## 2.0 REVISED PROJECT DESIGN

### 1. INTRODUCTION AND REVISED PROJECT DESIGN OVERVIEW

FIGURE **F-1**

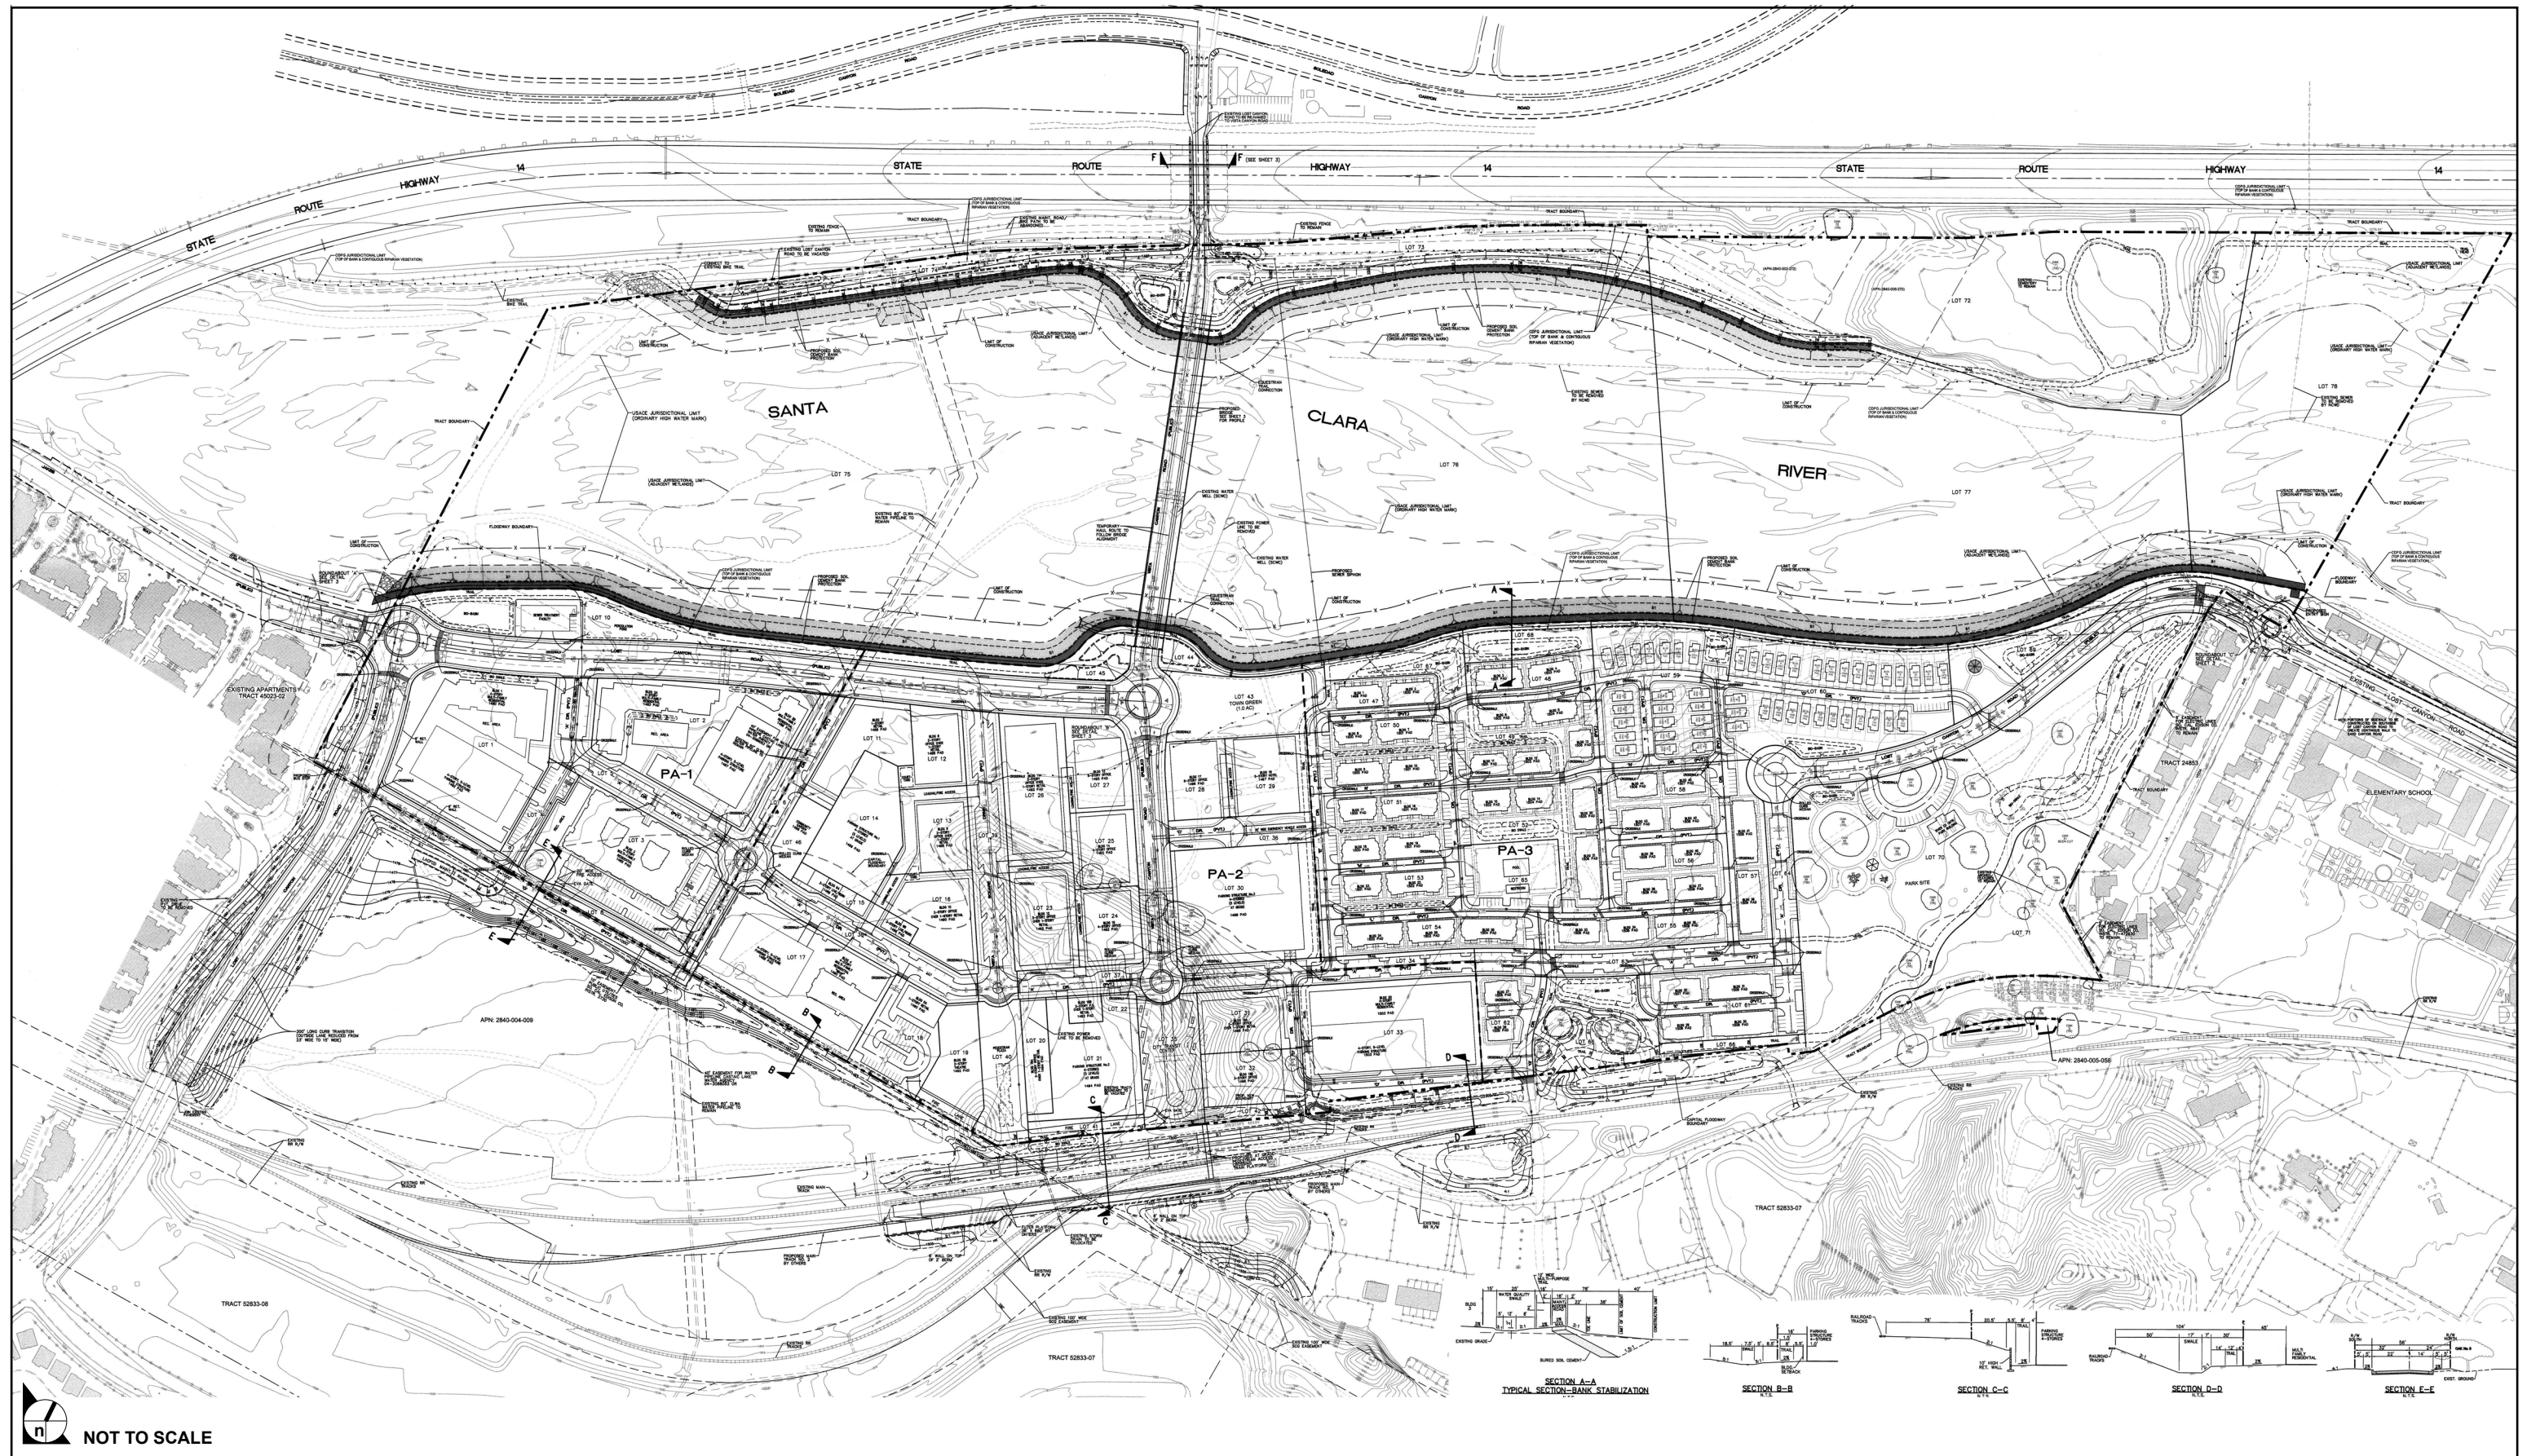
**Table F-1, Vista Canyon Revised Statistical Summary**, also provides the land use statistical summary for the revised project. Additionally, the revised project is illustrated on **Figure F-1, Revised Land Use Plan**, and **Figure F-2, Revised Vesting Tentative Tract Map**, below. A narrative summary of the key changes to the original project studied in the Draft EIR also is provided below.

- **Residential Dwelling Units:** The maximum number of residential units has been reduced from 1,350 to 1,100 units, which is attributable to: (a) the elimination of the residential overlay option, and (b) the elimination of 26 single-family lots previously proposed for development in PA-3 adjacent to the existing La Veda Avenue community. As shown in **Figure F-2**, the units would be distributed as follows: PA-1 – 480 units; PA-2 – 325 units; and, PA-3 – 295 units.

- **Development/Grading Footprint:** The amount of developed acreage has been reduced from approximately 100 acres to approximately 89 acres due to the elimination of development in PA-4 and the pull back of bank stabilization in PA-1 and PA-2.

- **Parks and Open Space:** The amount of parks and open space has increased from 18 to 21 acres due to the elimination of 26 single-family lots previously proposed for development in PA-3 adjacent to the existing La Veda Avenue community.
